ADDENDUM NO. 3

Bid Name SW 40th Extension and SW 47th Ave Trail

Bid No.: WSPP-180086-DM

INDEX OF ROADWAY PLANS

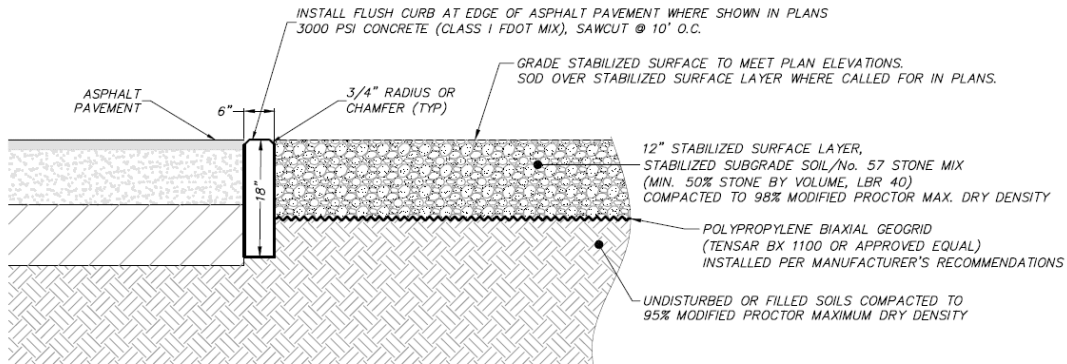
3. Question: Sht.#10 missing from plans

Answer: Correct. Please refer to the cover sheet of the SW 40th Boulevard Extension Project. This sheet was not used.

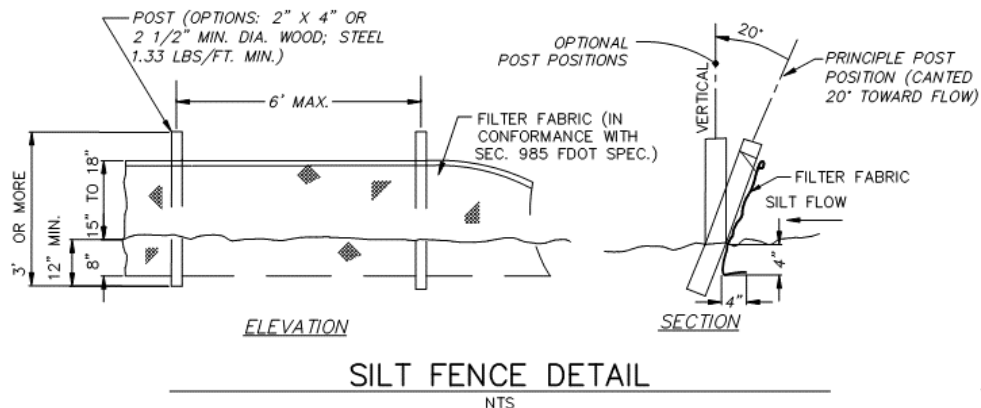
5. Question: Ribbon Curb is shown in pay items, but we cannot locate on plans.

Answer: Please see the Stabilized Path Detail on Sheet 11:

Ribbon Curb shall be provided at the edge of asphalt pavement when adjacent to the Stabilized Path. The curb and path location is shown on sheets 17, 18, 19, and 20
